# Corpus Christi LE- ADA Evaluation

## LE- Corpus Christi TX, ADA Evaluation

Accessibility Evaluation

Inspection Date: 02/15/2023

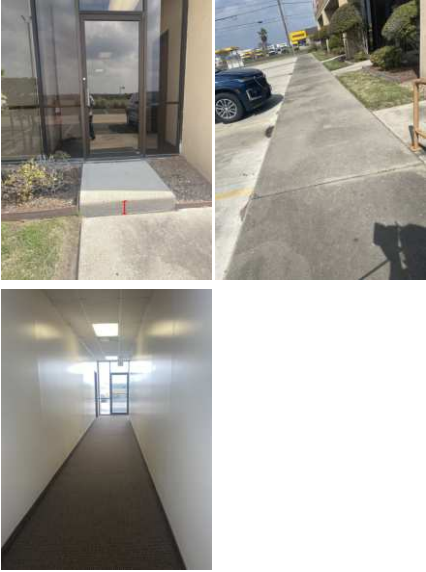
Finding Number	Area Description	Finding	As Built	Recommendation	Citation	Photos	Figure
6	Exterior of Property (Public): Path of Travel to Building - Entrance Ramp (Non Curb Ramp)	The handrails do not meet minimum height requirements. Handrails are measured to the top of the gripping surface and must be between 34 inches and 38 inches above the ramp surface. Handrails must extend horizontally 12 inches beyond the top and bottom of the ramp.	Entrance ramp handrail height measured at 32.5"	<a href="https://www.access-board.gov/ada/#ada-505_4">https://www.access-board.gov/ada/#ada-505_4</a>	2012 TAS Section: 505.4  2010 ADAS Section: 505.4		
7	Exterior of Property (Public): Path of Travel to Building - Entrance Ramp (Non Curb Ramp)	The ramp run has not been provided with edge protection. The floor or ground surface of the ramp run or landing shall extend 12 inches minimum beyond the inside face of a handrail or a curb or barrier shall be provided that prevents the passage of a 4 inch diameter sphere, where any portion of the sphere is within 4 inches of the finish floor or ground surface.	Edge protection not provided for entire ramp run, bottom rail looks over 4" 2 ways to satisfy compliance. 1- install bottom bar at 4" or less 2- add ground surface to extend 12" minimum from handrails	Edge protection <a href="https://www.access-board.gov/ada/#ada-405_9">https://www.access-board.gov/ada/#ada-405_9</a> Extended ground or floor surface <a href="https://www.access-board.gov/ada/#ada-405_9_1">https://www.access-board.gov/ada/#ada-405_9_1</a> Curb or barrier <a href="https://www.access-board.gov/ada/#ada-405_9_2">https://www.access-board.gov/ada/#ada-405_9_2</a>	2012 TAS Section: 405.9.1, 405.9.2  2010 ADAS Section: 405.9.1, 405.9.2

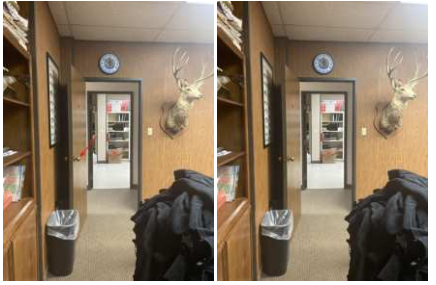
41	First Floor Main Building LOBBY (Public): Exterior Route to Public Restrooms - Restroom (Women's)	The paper towel dispenser is not accessible because there is not adequate clear floor space for either a forward or side approach. The clear floor or ground space shall be 30 inches minimum by 48 inches minimum.	Trashcan blocking access.	<a href="https://www.access-board.gov/ada/#ada-305_3">https://www.access-board.gov/ada/#ada-305_3</a>	2012 TAS Section: 305.3  2010 ADAS Section: 305.3
